UNITED STATES OF AMERICA
NUCLEAR REGULATORY COMMISSION

Diablo Canyon Power Plant)
Units 1 and 2)

License Amendment Request
No. 88-08

SAFETY EVALUATION
FOR THE
DIABLO CANYON POWER PLANT UNITS 1 AND 2
TRANSITION TO WESTINGHOUSE 17x17 VANTAGE 5 FUEL

DIABLO CANYON UNITS 1 AND 2
 FIGURE 3.1
 17X17 VANTAGE 5 / LOPAR
 FUEL ASSEMBLY COMPARISON

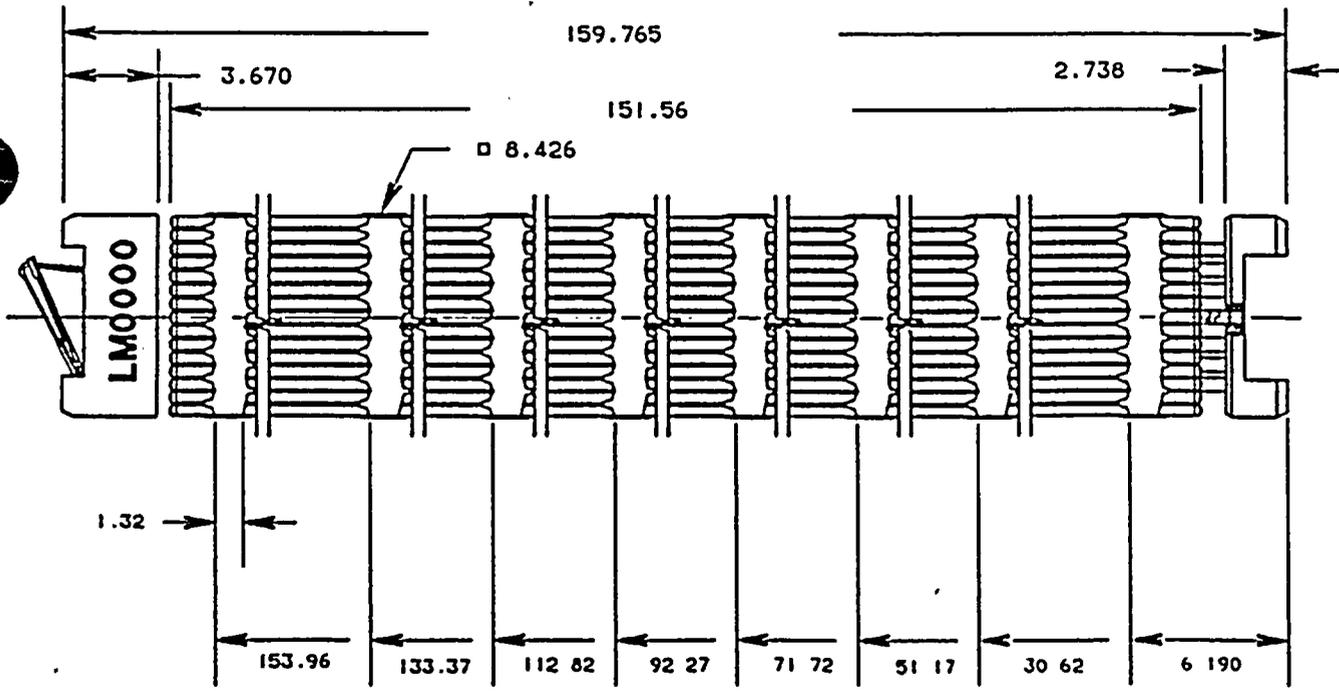
The Intermediate Flow Mixer (IFM) grids shown in Figure 3.1 are located in the three uppermost spans between the Zircaloy mixing vane structural grids and incorporate a similar mixing vane array. Their prime function is mid-span flow mixing in the hottest fuel assembly spans. Each IFM grid cell contains four dimples which are designed to prevent midspan channel closure in the spans containing IFMs and fuel rod contact with the mixing vanes. This simplified cell arrangement allows short grid cells so that the IFM grid can accomplish its flow mixing objective with minimal pressure drop. The IFM grids are not intended to be structural members. The outer strap configuration was designed similar to current fuel designs to preclude grid hang-up and damage during fuel handling.

The reconstitutable top nozzle for the VANTAGE 5 fuel assembly differs from the LOPAR design in two ways: a groove is provided in each thimble thru-hole in the nozzle plate to facilitate attachment and removal; and the nozzle plate thickness is reduced to provide additional axial space for fuel rod growth.
